| DATE 19 February 1964 | | TMC SPECIFICATION NO. S-817 | A |

TITLE: ALDC MODIFICATION - KIT-130

A. PURPOSE

1. To provide automatic load and drive control (ALDC) on Model PAL-1K.
2. To permit compatibility with sideband exciters (SBE-2 & SBE-3) and controlled harmonic generators (CHG-2) now containing ALDC provisions.

FIG. 1.

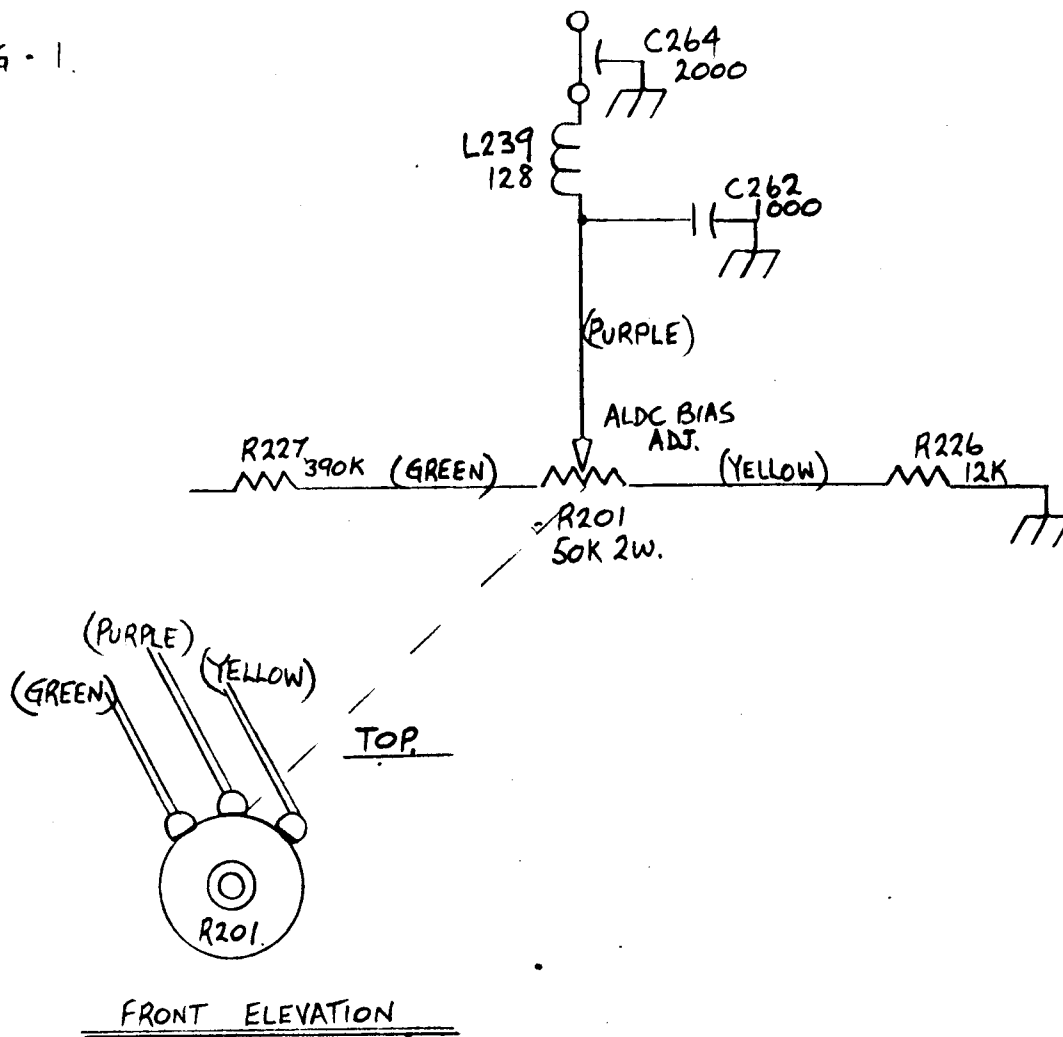
5. Cut or unsolder the 3 wires on R201 (ALDC BIAS ADJ) of RFD-1.
6. Remove R201 and discard.
7. Remove the four mounting screws on TB-201.
8. Refer to Fig. I (color coding of wires may differ from that shown). Unsolder the yellow wire side of R226, and the green wire side of R227 (both mounted on TB-201).

11. Remove the rear cover of meter panel (M201 & M202).
12. Refer to Fig. 2. Mark front panel as shown, center punch, and drill ALDC hole with Item 13.
13. Refer to Fig. 1. Solder wires, Items 10, 11, 12 to Item 2 as shown.

14. Mount potentiometer (Item 2) in the new ALDC hole (Step 12) with the wired contacts facing the top of the RFD, (see Fig. 1).
15. Attach Item 4, (indicator dot on knob should be fully CCW when shaft is fully CCW).

16. Affix Item 20 to the front panel under knob.
17. Pass the 3 wires from the ALDC pot through the rubber grommet into the bottom section of the RFD-1 and lace with Item 5 to the main chassis cable so that they can be soldered to components (ref. Fig. 1).

REAR ELEVATION RFD

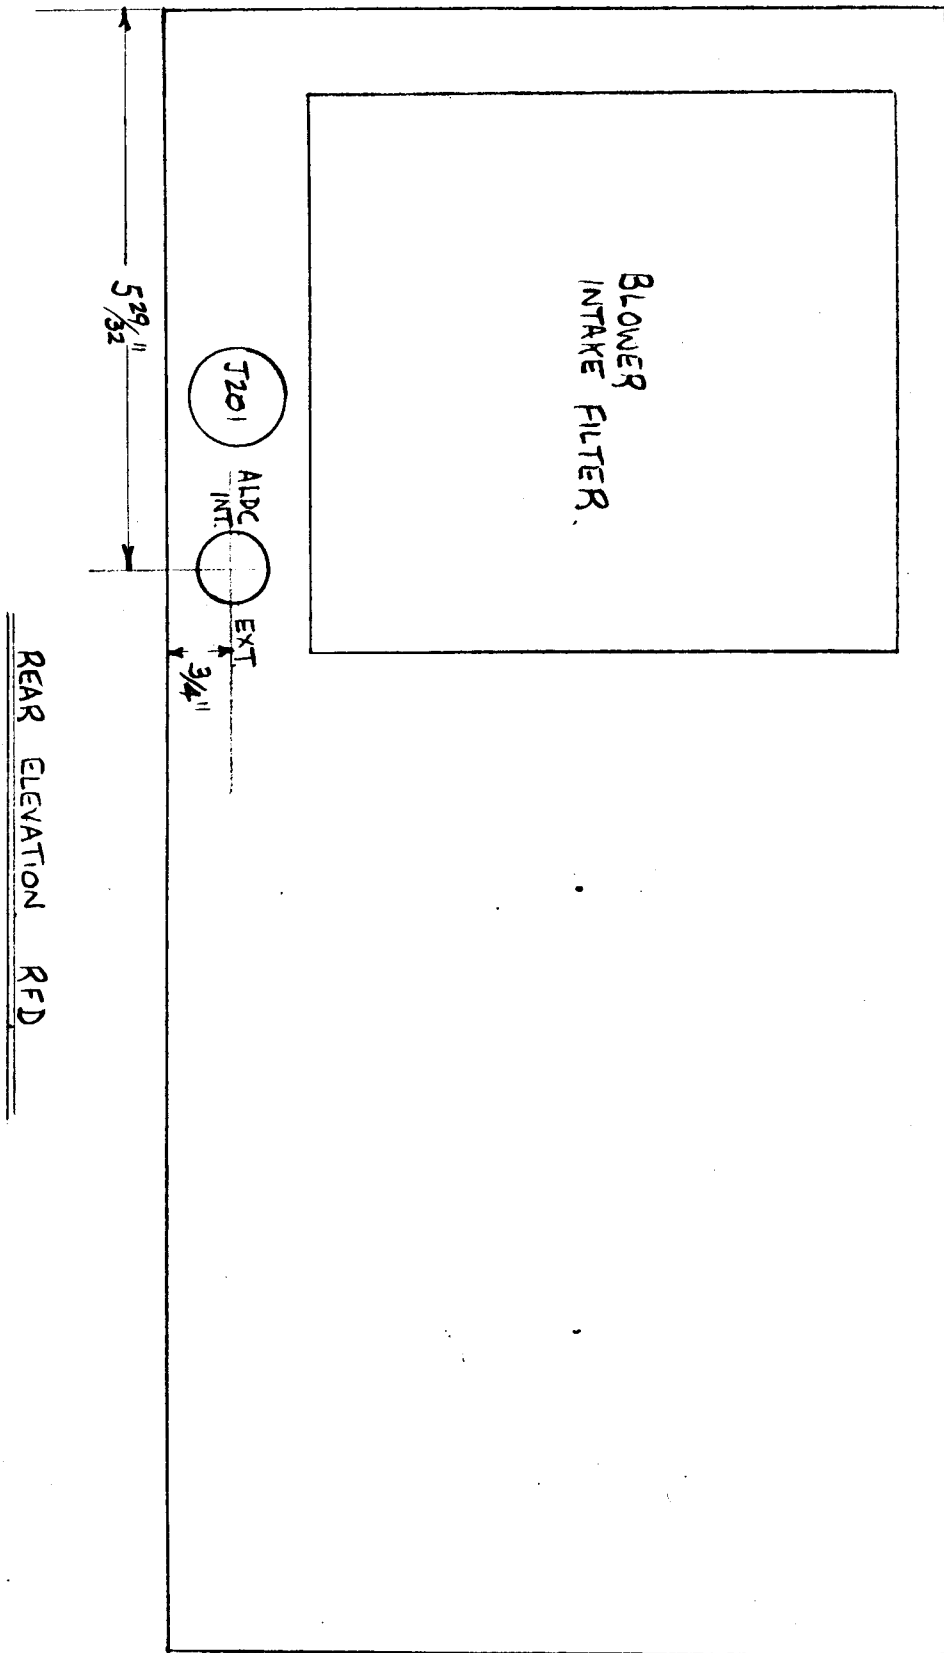
19. Refer to Fig. 3. Unsolder and remove from the main chassis cable the continuous wire from L240 to L242, (L242 is mounted on TB-201; L240 is mounted top LHS blower compartment).

20. Use Item 14 to enlarge hole vacated in Step 6 (ref. Fig. 4).

21. Refer to Fig. 3. Solder wires, Items 7, 8, & 9, to Item 3 as shown. Mount Item 3 in enlarged hole (Step 20).

23. Arrange the 3 wires from the ALDC switch so that they can be soldered to components (ref. Fig. 3). The blue/white stripe wire will go to L240 (Step 19). The white wire goes to L242 (Step 19), the orange wire goes to Pin "b" P201. Lace wires with Item 5 wherever possible.

REAR ELEVATION PS-4,
CHASSIS REAR ONLY.

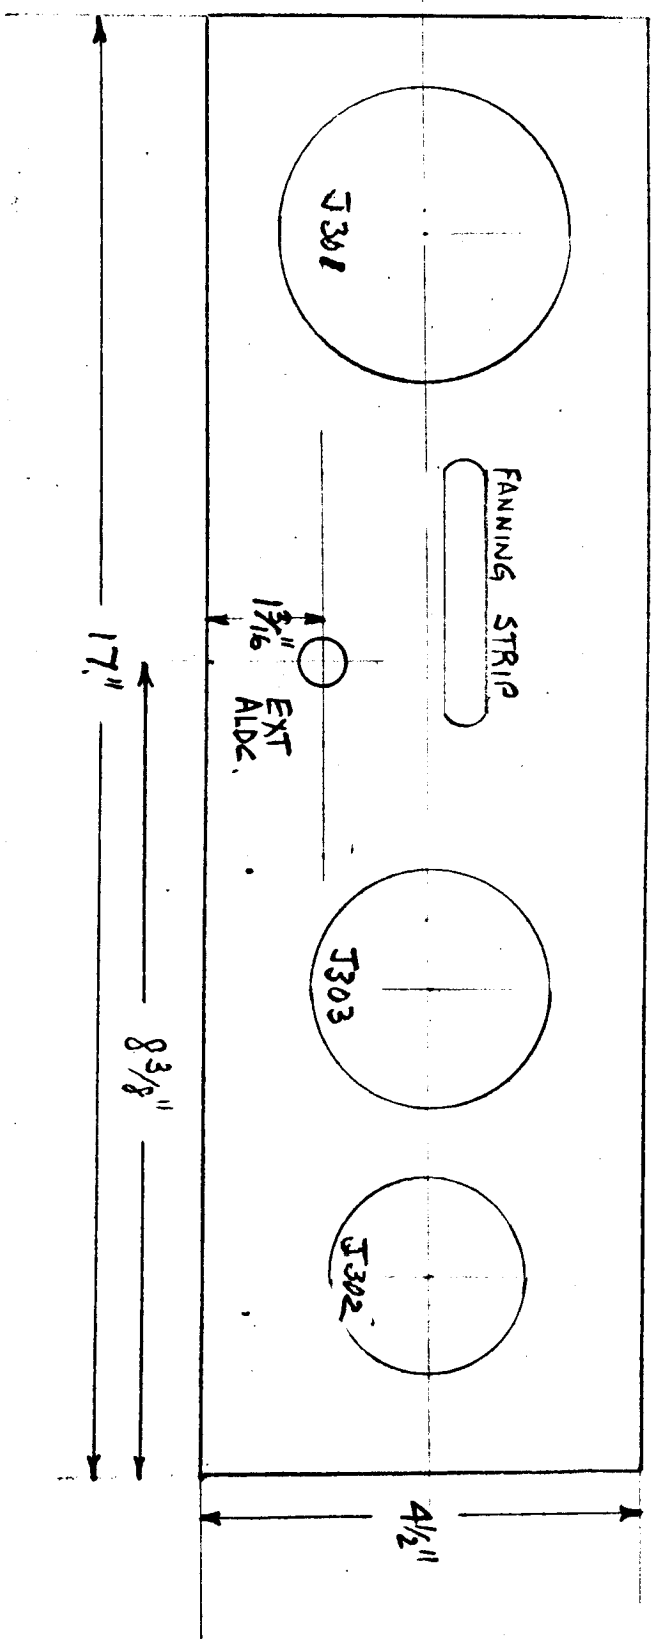
28. Refer to Fig. 5. Mark, center punch, and drill EXT ALDC hole in PS-4 chassis with Item 15, as shown.

29. Mount Item 1 in EXT ALDC hole.

DRILLING PLAN
EXT ALDC HOLE 7/16" DIAMETER.
